DEVIATION REQUEST AND DECISION FORM

Project Name : SF1819: Lorson Ranch East Filing 2

A deviation from the standards of or in Section **El Paso County Standard Drawing of the Engineering Criteria Manual (ECM) Detail SD 4-20**, is requested.

Exhibit showing Chemical
Grout Locations on Lorson
Ranch East Filing 2

SITE VISIBILITY AND PUBLIC IMPROVEMENT EASEMENT (TYP.)
DETAIL A
NOT TO SCALE

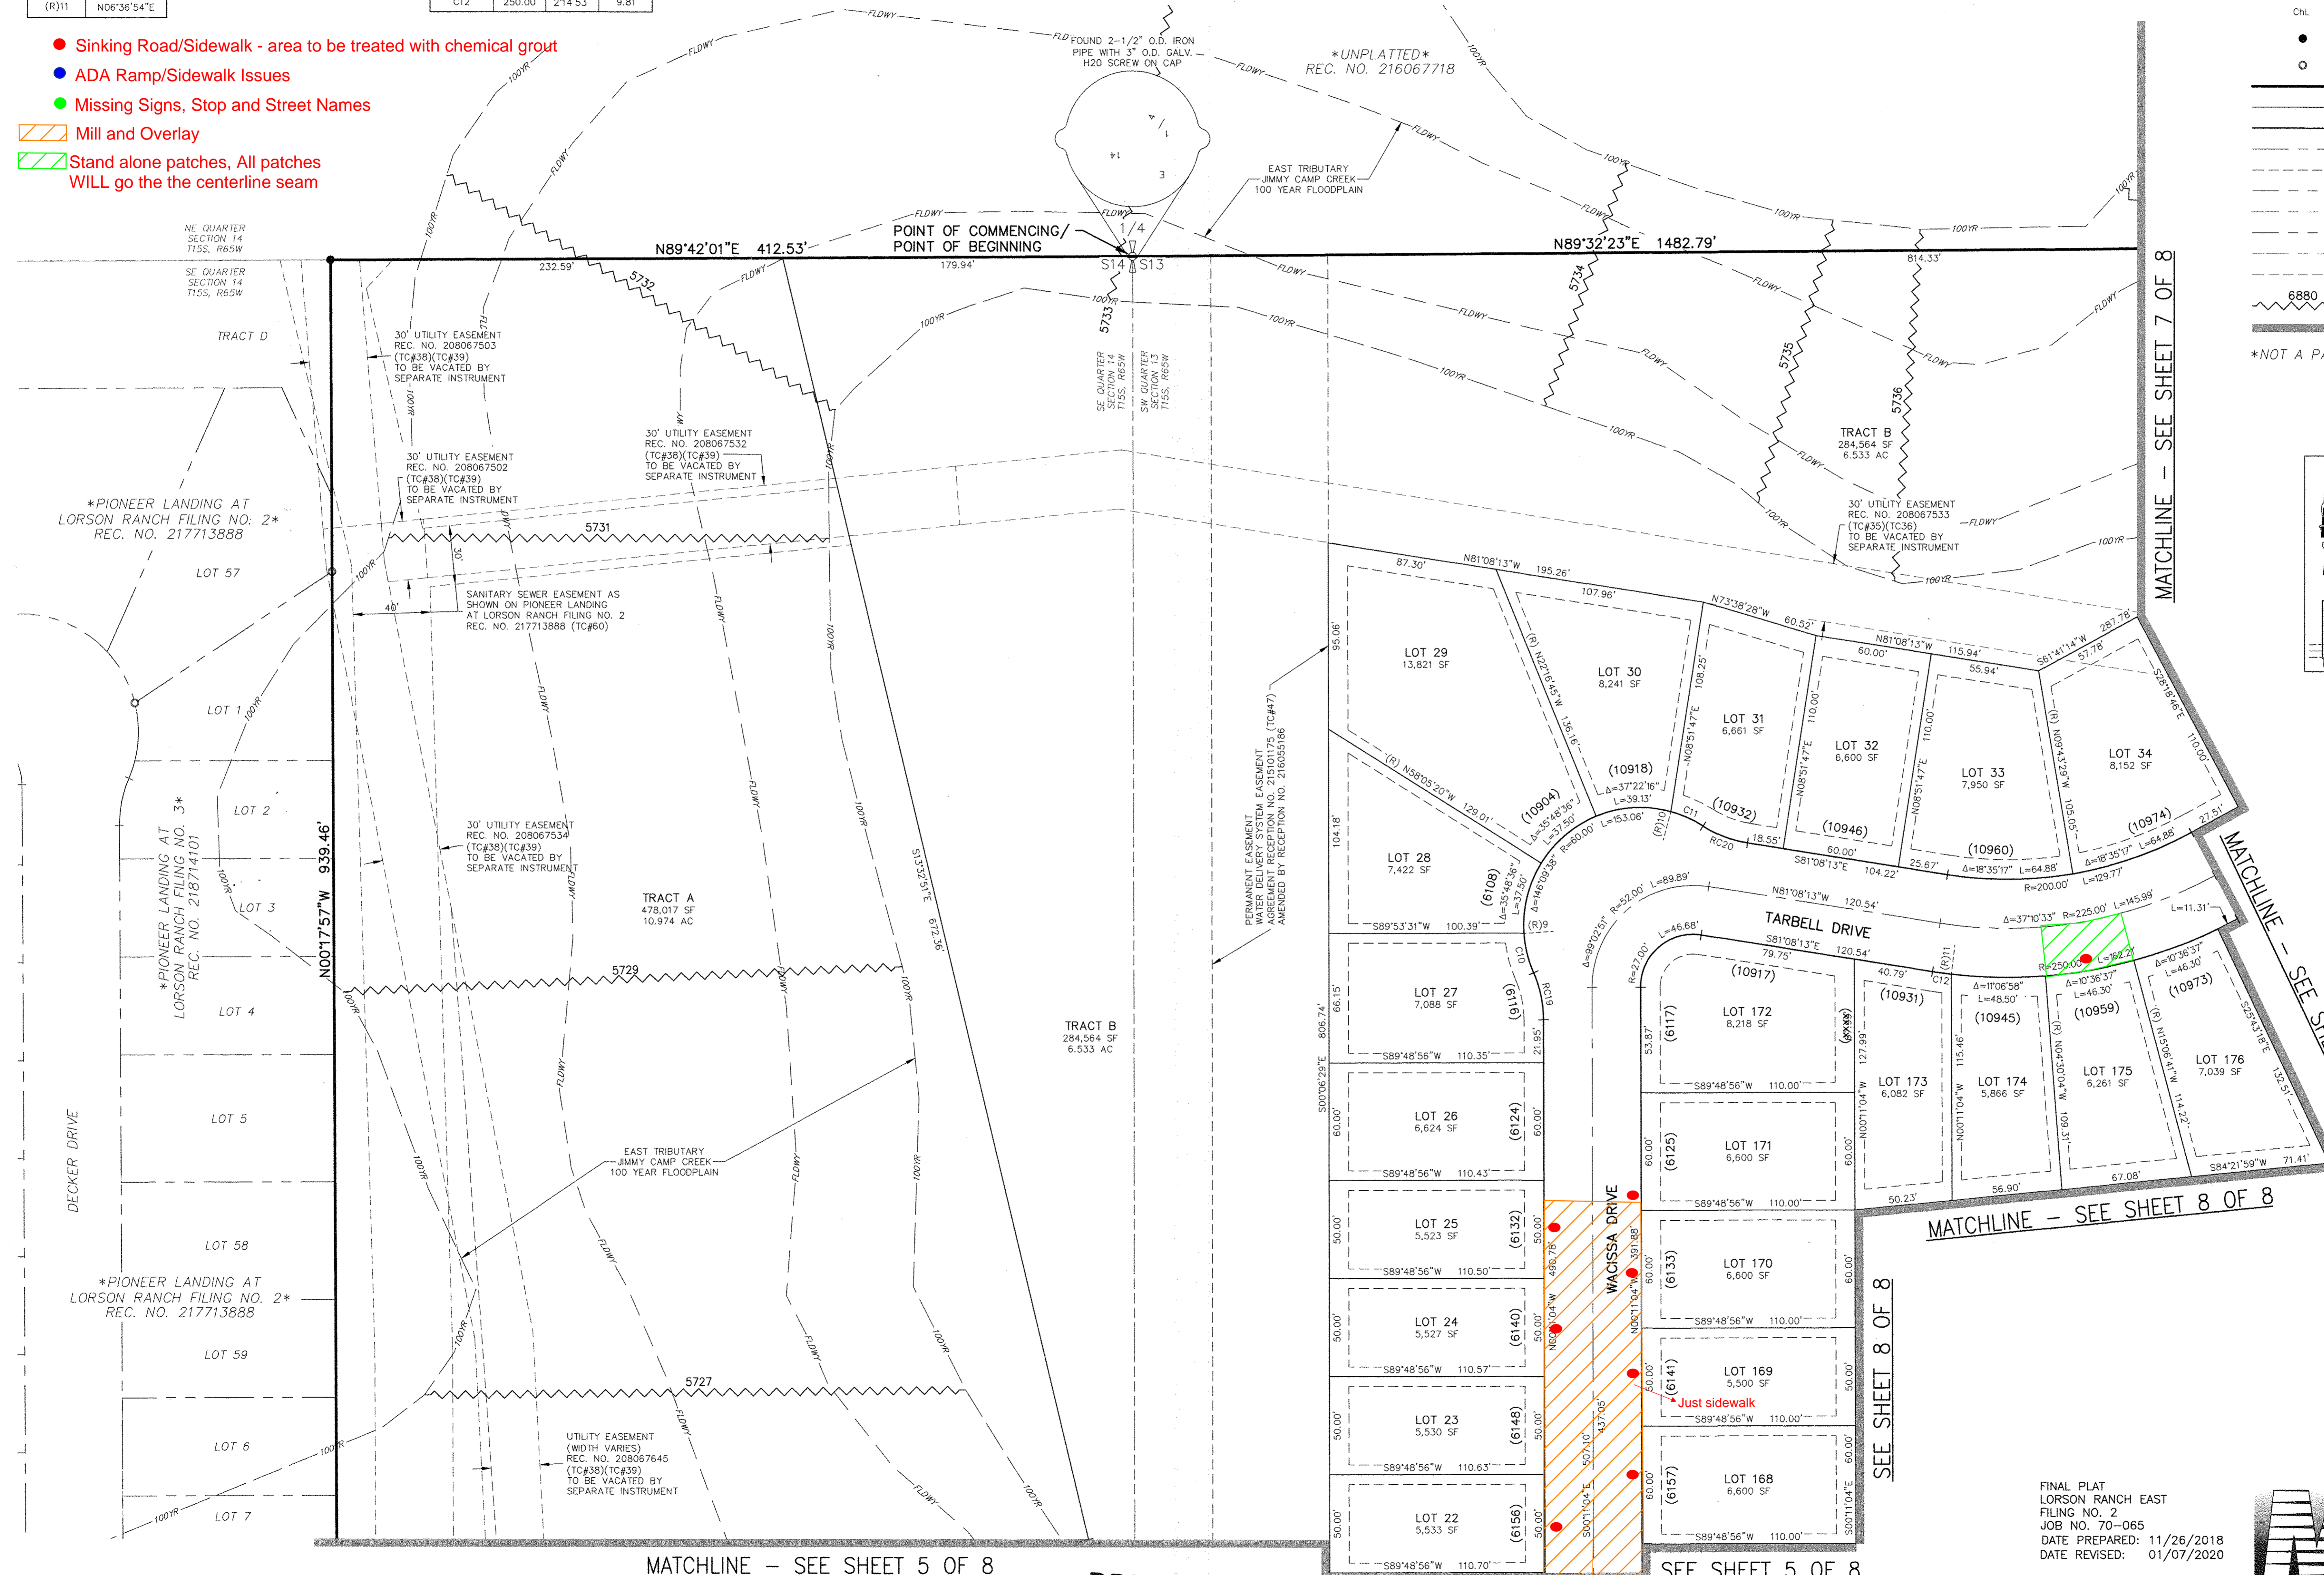
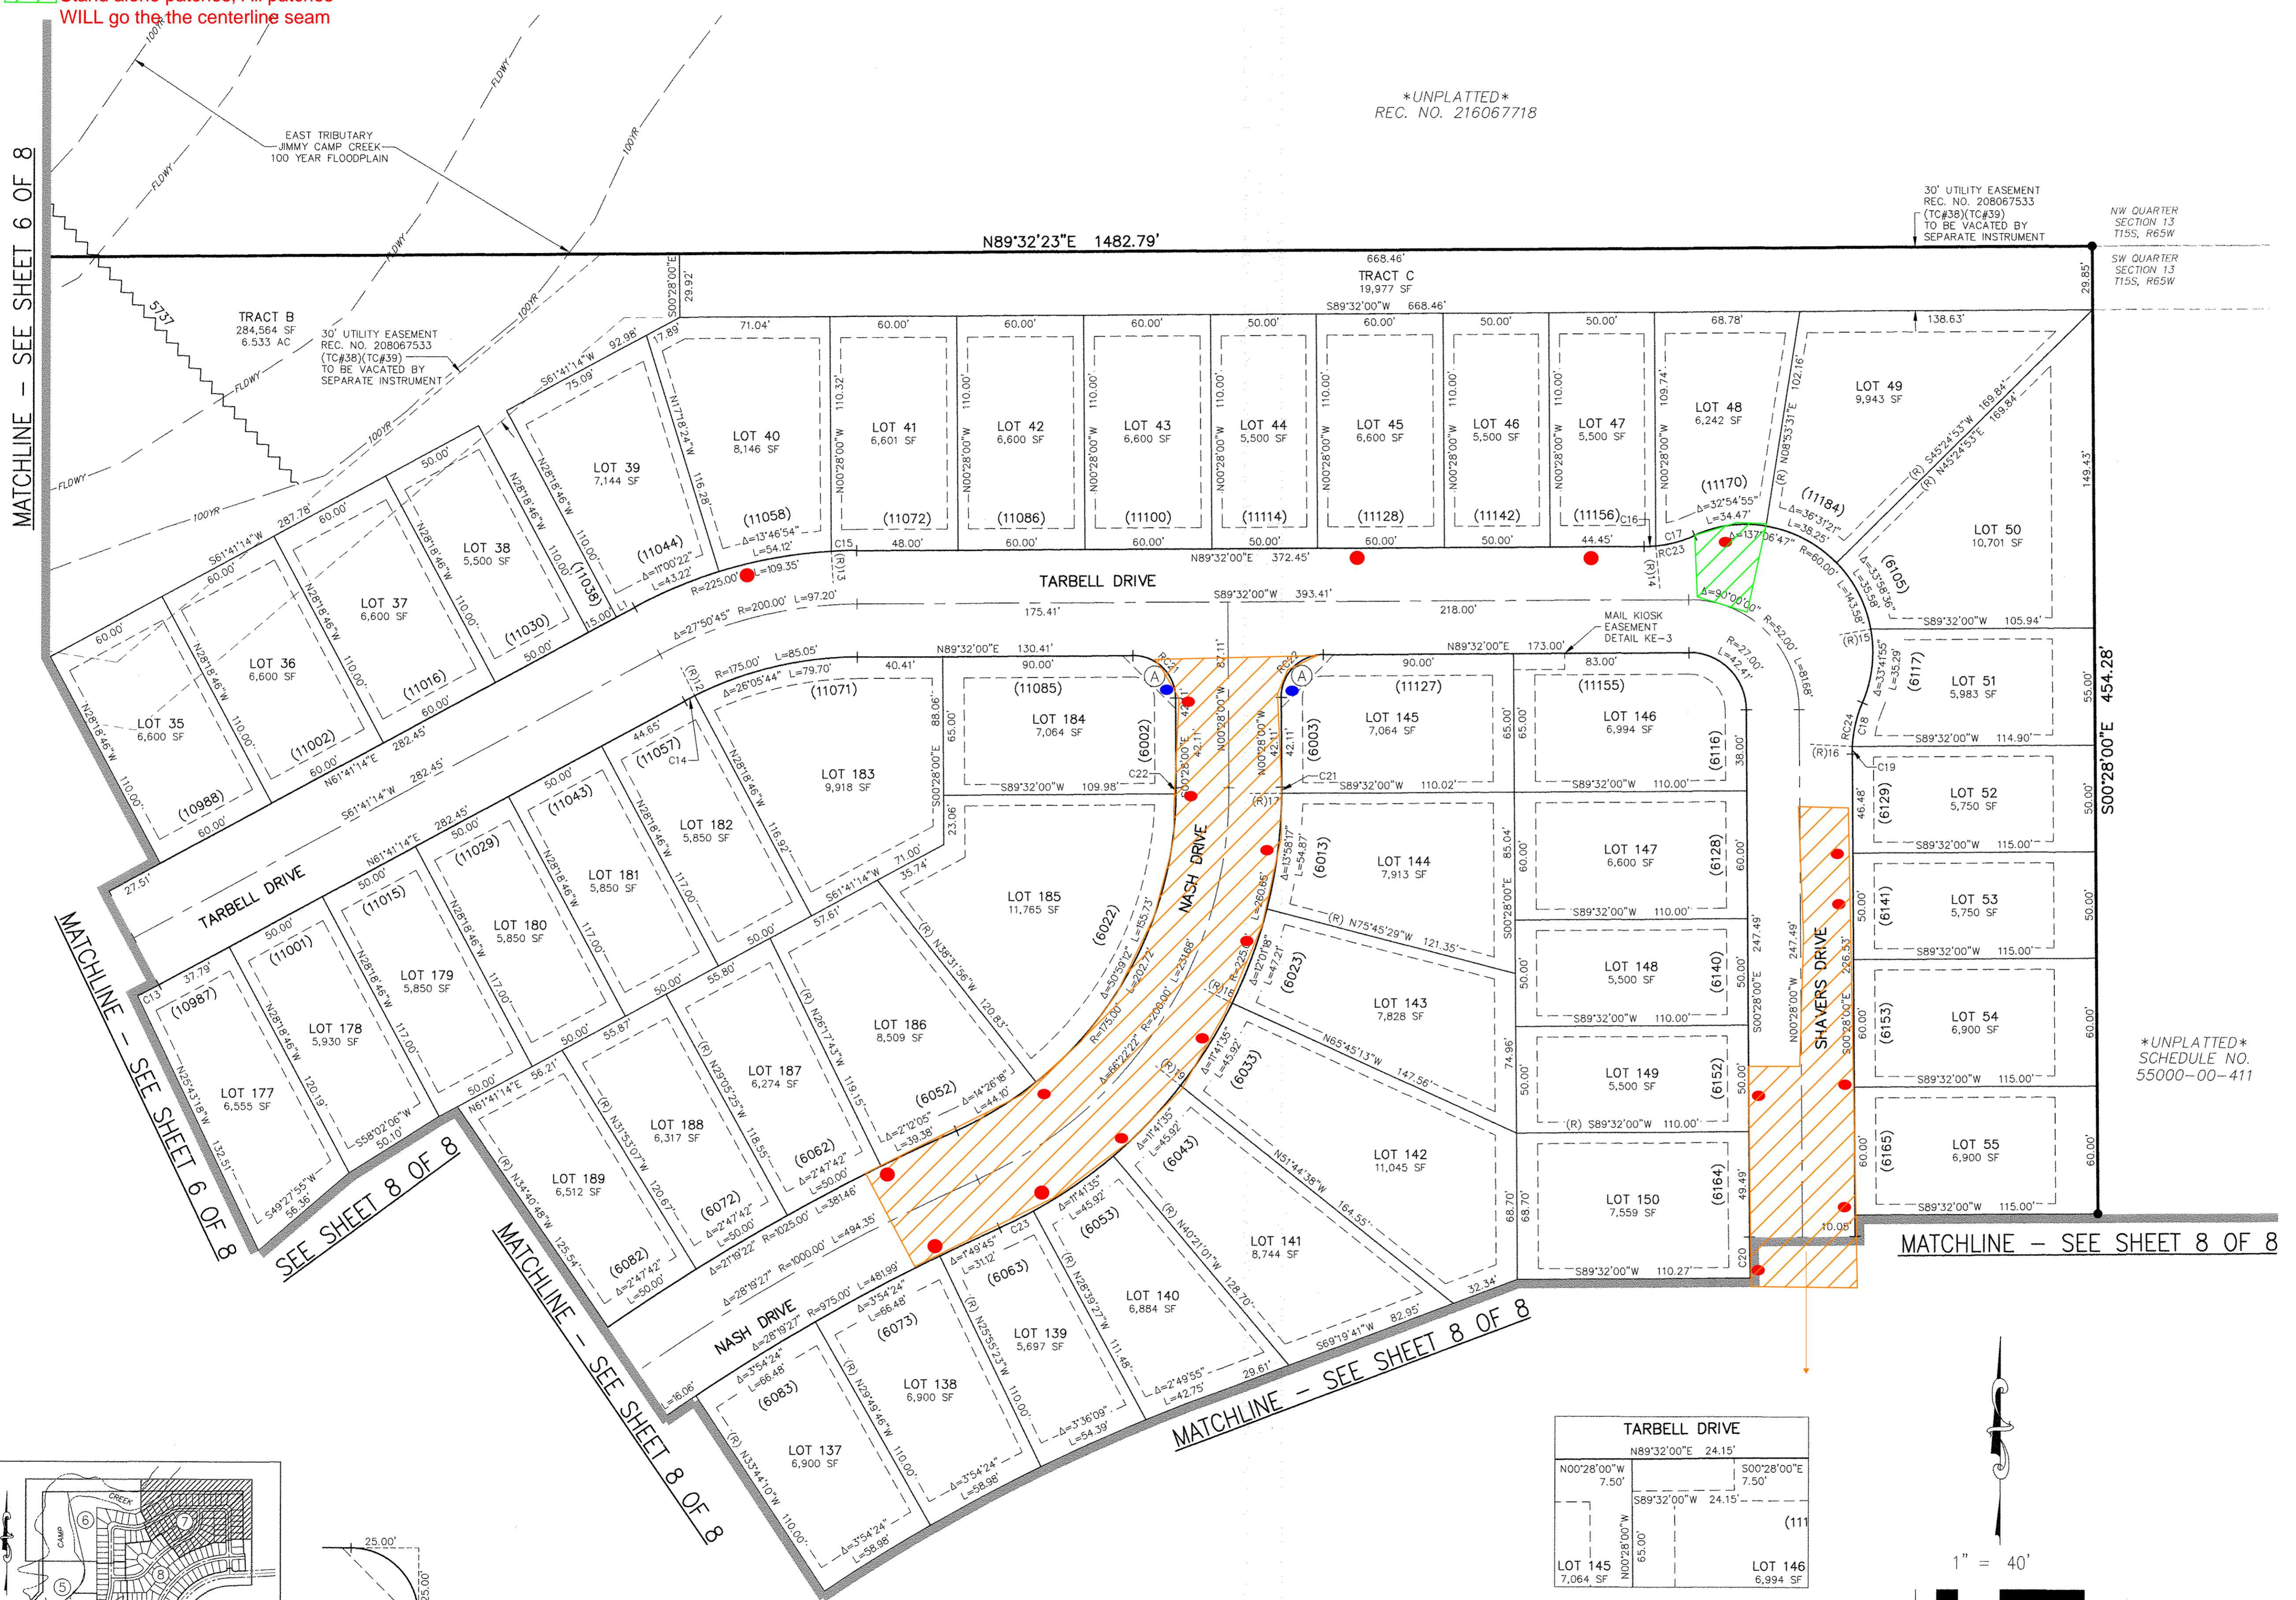
Deviation request for the use of the chemical grout to stabilize the soils within the roadway and utility trenches where settlement and distress were observed and to lift and relevel pavement, concrete flatwork, and stormwater catch basins. The deviation request is requested for Lorson Ranch East Filing 2 (File# SF1819)

The chemical grout should initially be injected approximately 4 feet on center within the utility trenches through a 1/2" injection rod advanced to a depth no greater than 4 feet below land surface (bls) through 5/8" diameter drilled holes. After an initial stabilizing injection volume that will be determined on a case-by-case basis, the injection rod tip will be raised to approximately 1.5' to 2' bls or within 0' to 1' ft bls of the base of the cement-treated subgrade (CTS) to lift and relevel the concrete slabs or pavement. When being utilized to relevel installed stormwater vaults, concrete sidewalks, or concrete curbs, the material will be injected directly beneath the concrete. The elevations of the pavement/slabs should be monitored continuously during the chemical grouting process.

please discuss whether roadway load capacity is impacted or still met by the use of this product.

Additionally, address the lifespan of the product and provide the specific product information for the proposed products listed above.

lastly, please provide the details of the 2-year warranty. What does it cover, who are the contacts should issues occur. Is there a contract # that is to be referred to if calling on the warranty is needed etc.

FYI. The following conditions of approval will be added by staff upon approval:
-As-Built drawings shall show the locations where the chemical grout was applied.
-A Notice to Proceed from EPC is required prior to the installation of the chemical grout.
-EPC inspections staff shall be present at each application of the chemical grout.
-Work a ROW permit shall be obtained for each subdivision that is currently in Preliminary Acceptance.
-An amended SIA with updated surety is required for subdivisions seeking Preliminary Acceptance.
